ADDENDUM No. 01

Coaldale Government Building

Project No.: 9030

Project:	Coaldale Protective Services Building	File No.	841-004
Client:	Stephens Kozak – ACI Architects and Planners	Addendum No.	S1
Copy:		Date:	February 12, 2019

DRG. TITLE: NEW SECTION 7 ON S3.5

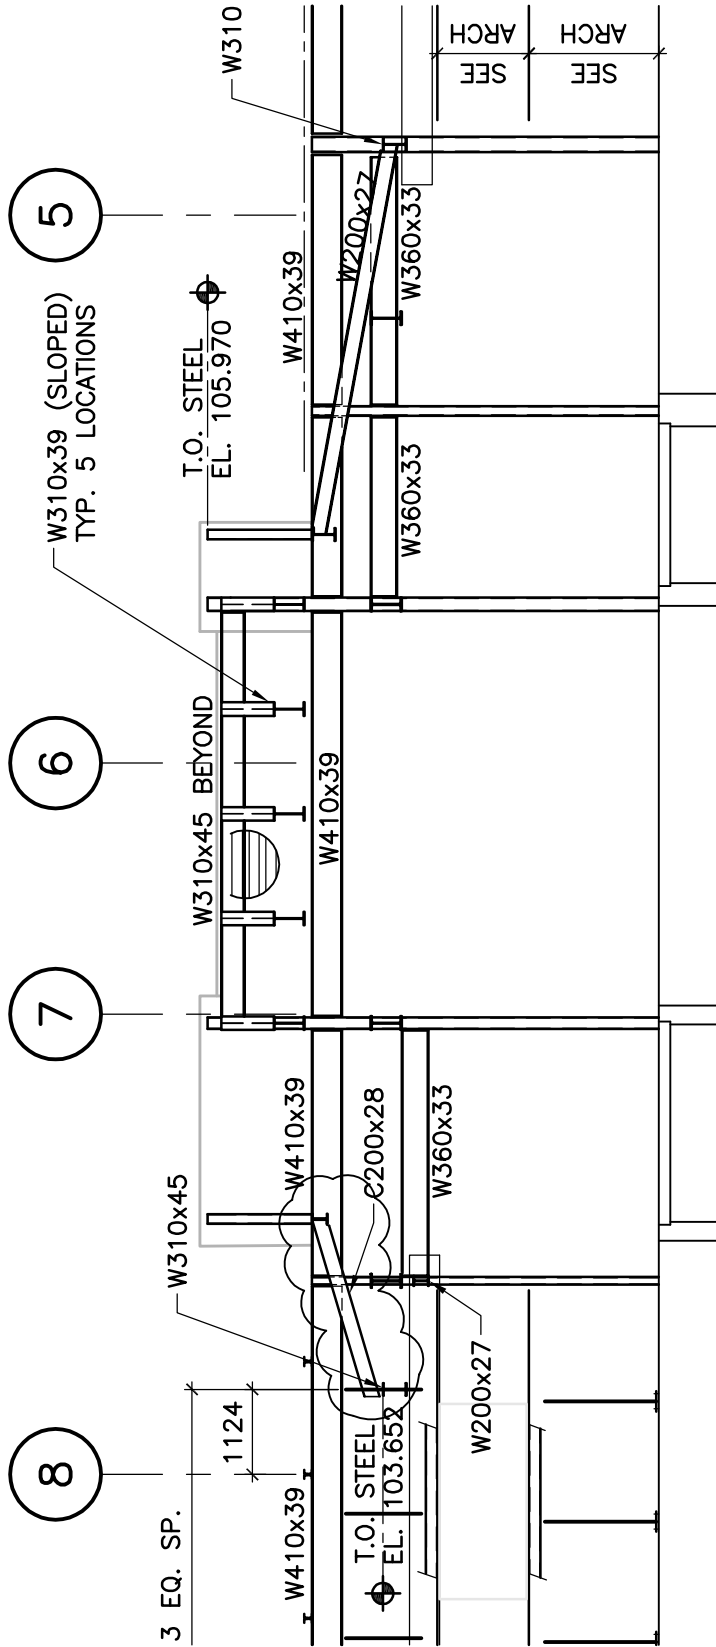
- .12 **Drawing S3.5 Roof Sections Sheet 5**
 - .12.1 Add new section 7/S1.6 as shown on SSK-011.
 - .12.2 Revise section 4 as per SSK-019.
- .13 **Drawing S4.1 Wall Elevations Sheet 1**

D ELEVATION AT GL B (NORTH)
S1.2 1:100

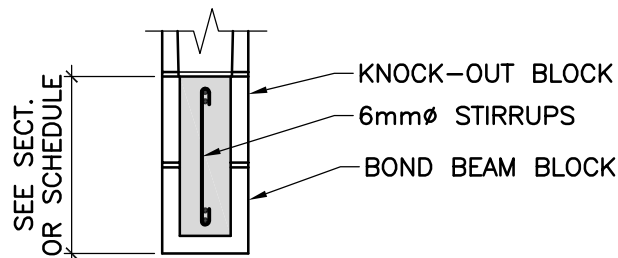
- .13.1 On Elevation A the O/H door between gridlines 1 and 2 is lowered to 3600 high.
 - .13.2 Revise Elevation D as clouded on SSK-012.
- .14 **Drawing S4.2 Wall Elevations Sheet 2**

SSK-013

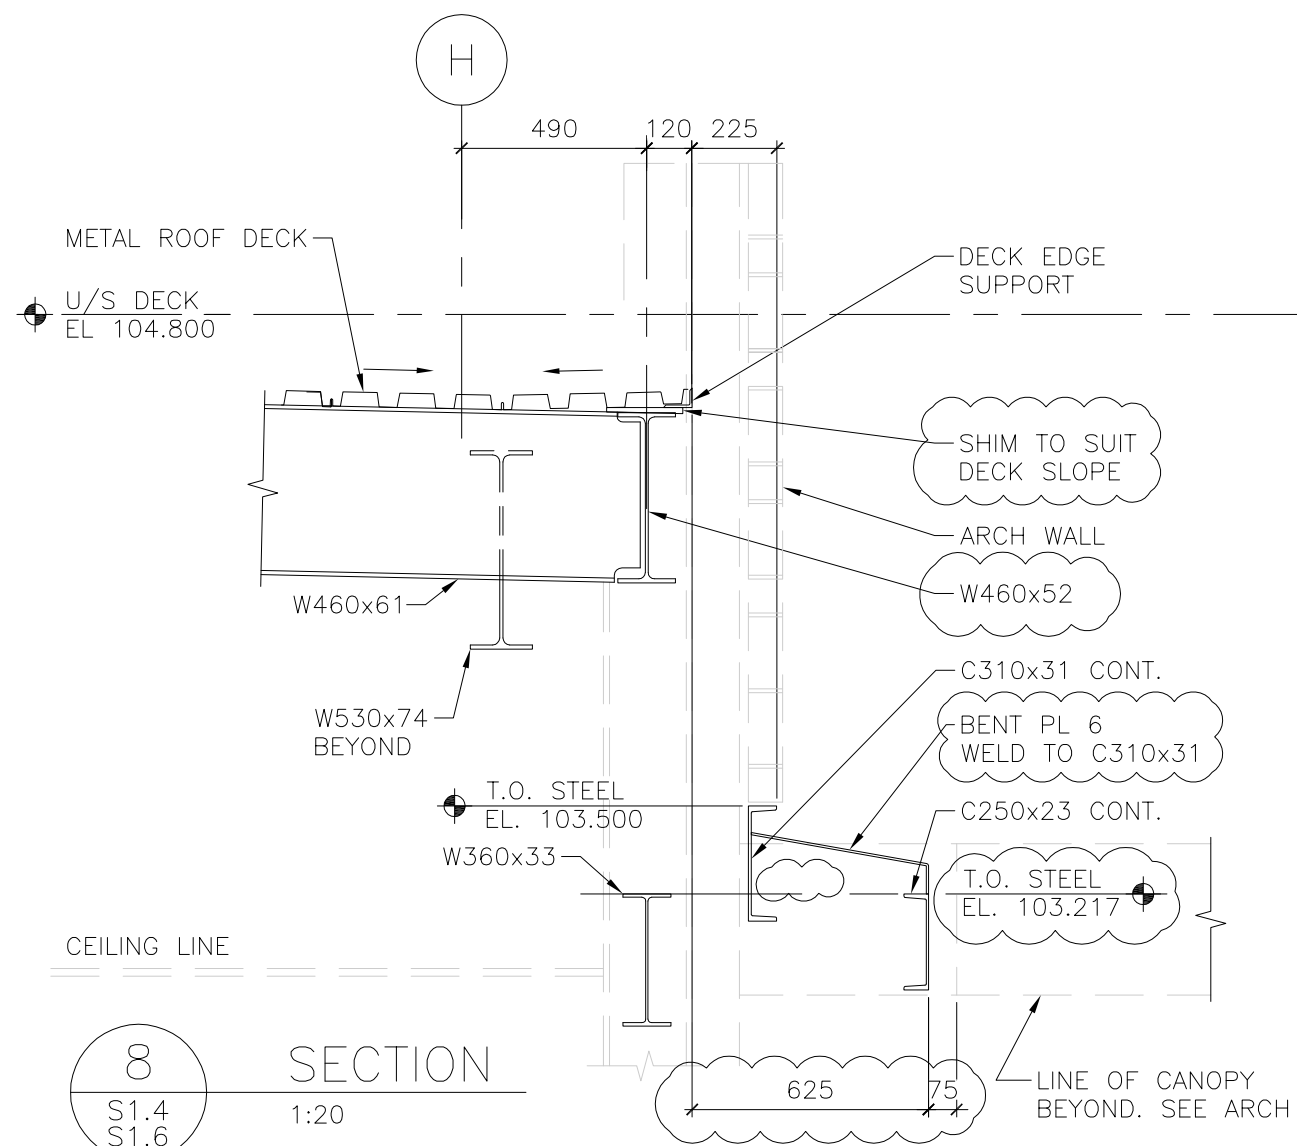
.1.1 Revise Masonry Lintel Schedule as clouded on SSK-013.

<p>Suite 200, 4220-98 Street NW Edmonton, AB T6E 6A1</p> <p>(780) 436-5376 www.bptec.ca</p>	PROJECT : STEPHENS KOZAK ACI ARCHITECTS COALDALE PROTECTIVE SERVICES BUILDING		
	DRG. TITLE : REVISED MECH. ROOF FRAMING PLAN		
DRAWN : NM	DATE : FEB. 12, 2019	FILE No. : 841-004	SKETCH No. : SSK-014

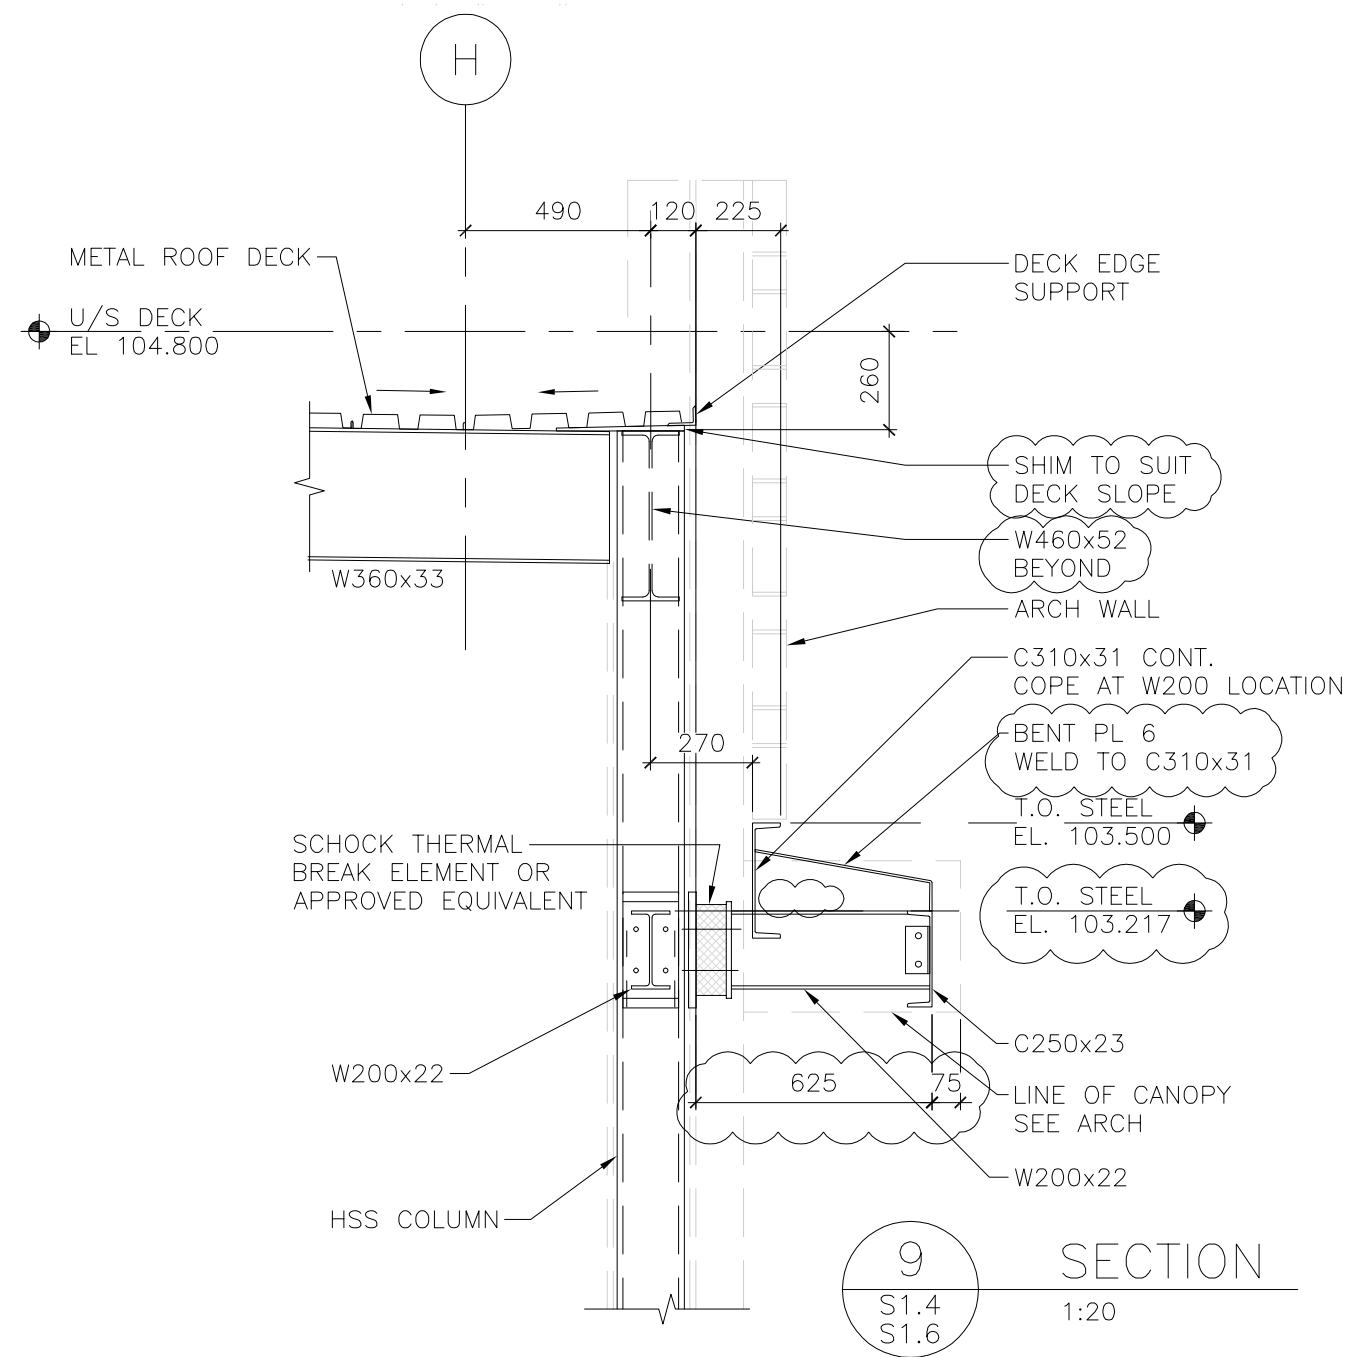
.5.1 Revise Mechanical Roof Framing Plan as per SSK-014.

PROJECT: STEPHENS KOZAK ACI ARCHITECTS COALDALE PROTECTIVE SERVICES BUILDING			
DRG. TITLE: REVISED SECTION 8 AND 9			
DRAWN: NM	DATE: FEB. 12, 2019	FILE No.: 841-004	SKETCH No.: SSK-015

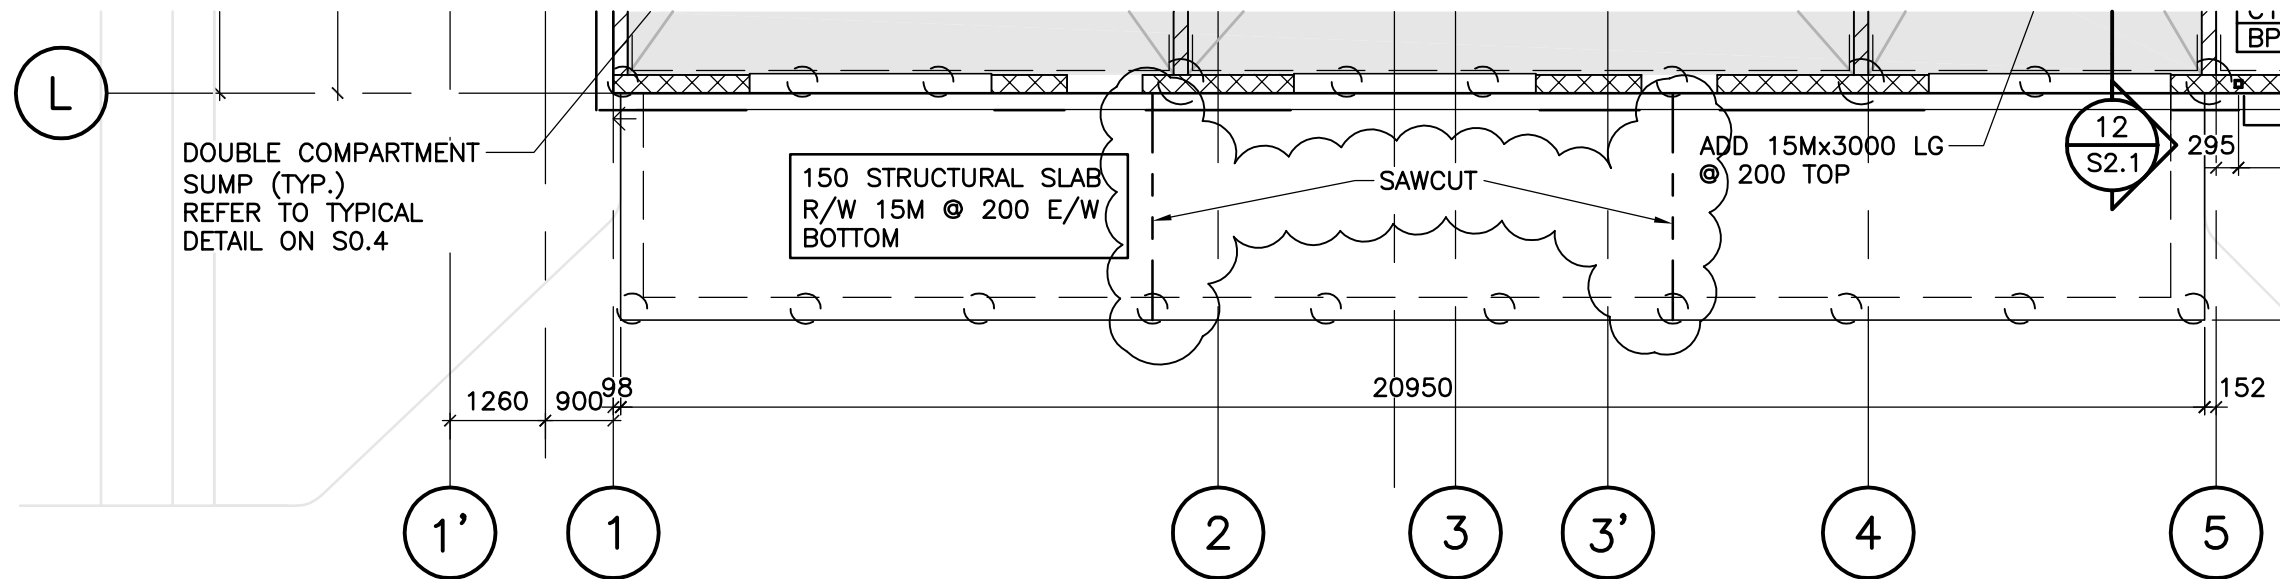
- .8.7 On section 8, revise note 'Bent PL 6' to read 'Bent PL 6 Weld to C310x31'.
Add note 'Shim to Suit Deck Slope' at deck counter slope as per SSK-015.
Delete deck inside canopy as per SSK-015.
Add dimension string 625 and 75 as clouded SSK-015.
Revise beam W360x33 to read W460x52 as clouded on SSK-015.

- .8.7 On section 9, revise note 'Bent PL 6' to read 'Bent PL 6 Weld to C310x31' as per SSK-015.
Add note 'Shim to Suit Deck Slope' at deck counter slope as per SSK-015.

Delete deck inside canopy as per SSK-015.

Add dimension string 625 and 75 as clouded on SSK-015.

Revise note 'W360x33 Beyond' to read 'W460x52 Beyond' as clouded on SSK-015.

PROJECT: STEPHENS KOZAK ACI ARCHITECTS COALDALE PROTECTIVE SERVICES BUILDING			
DRG. TITLE: ADDED SAWCUTS IN APRON SLABS			
DRAWN: NM	DATE: FEB. 12, 2019	FILE No.: 841-004	SKETCH No.: SSK-016

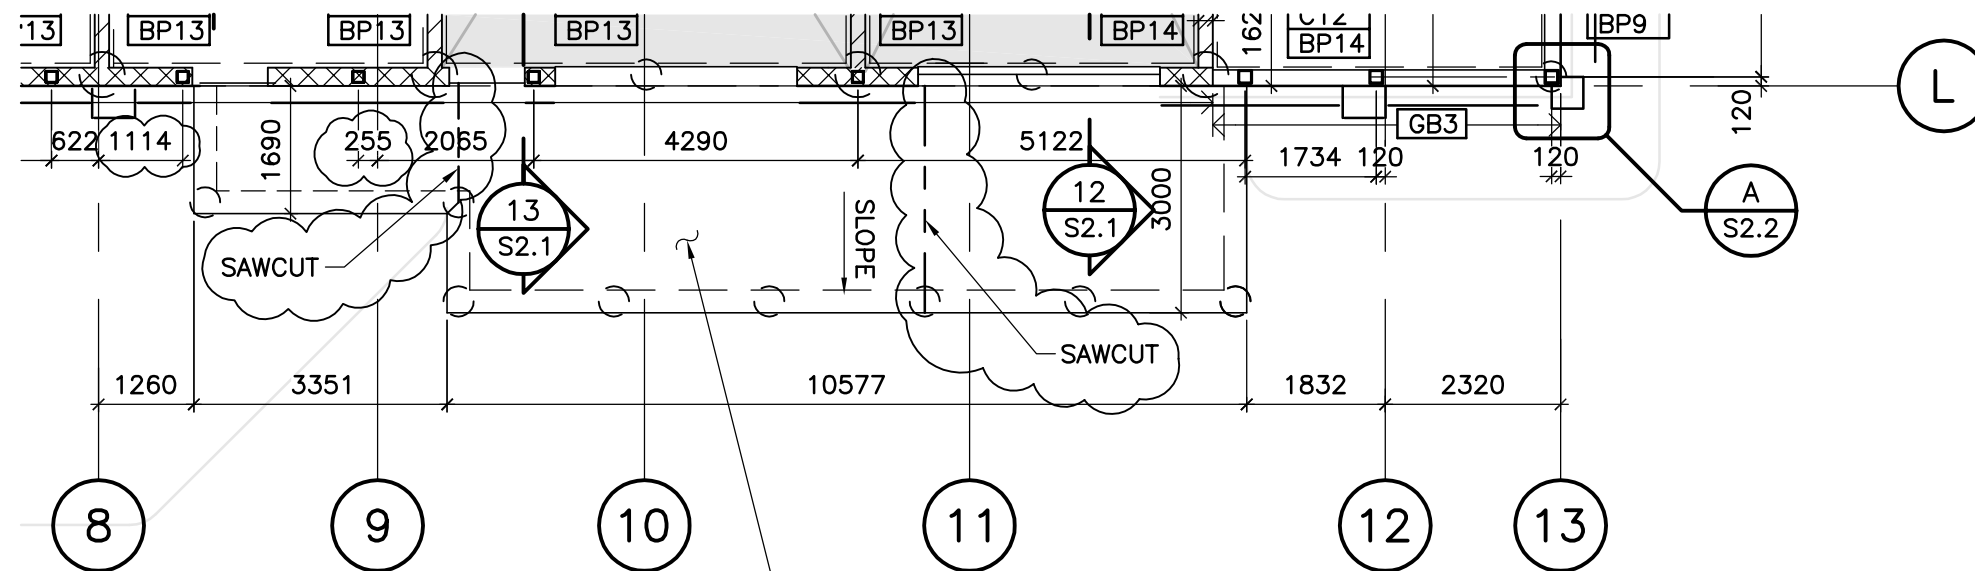
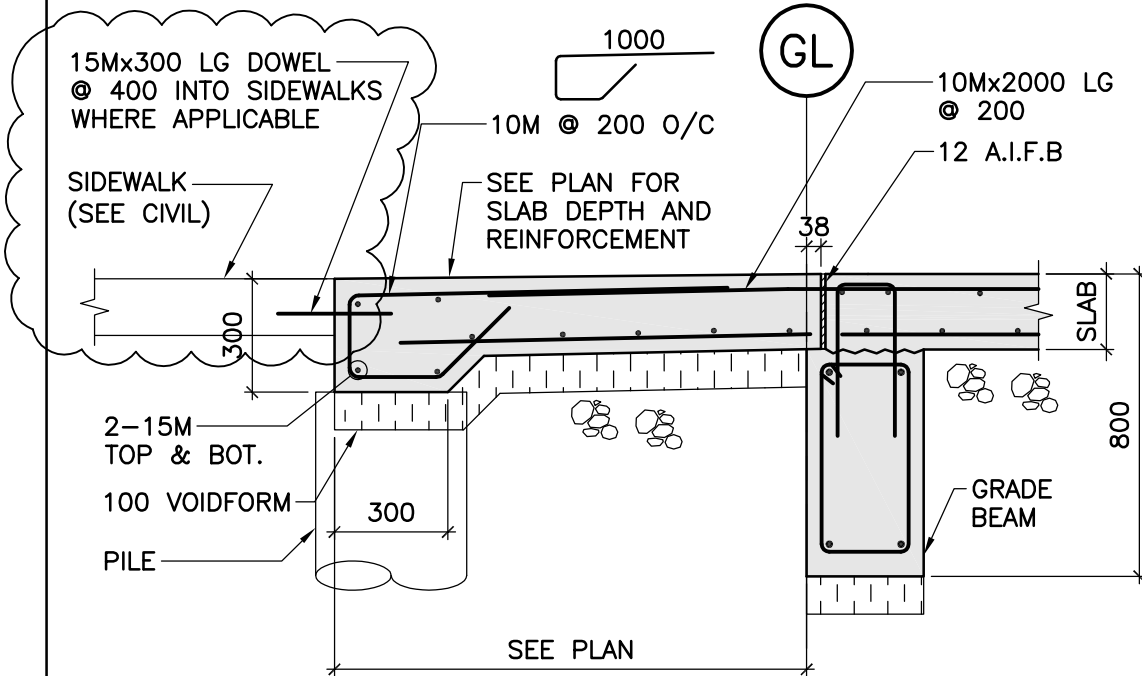
.3.3 Add sawcuts to apron slab at gridline L between gridline 1-5 as clouded on SSK-016.

.3.4 Add sawcuts to apron slabs at gridline L between gridline 8 (+1260) and 12 (-1832) as clouded on SSK-016.

.3.6 Revise column dimension along gridline L, east of gridline 8 '1140' to read '1114' as clouded on SSK-016.

.3.7 Revise column dimension along gridline L, west of gridline 9 '342' to read '255' as clouded on SSK-016.
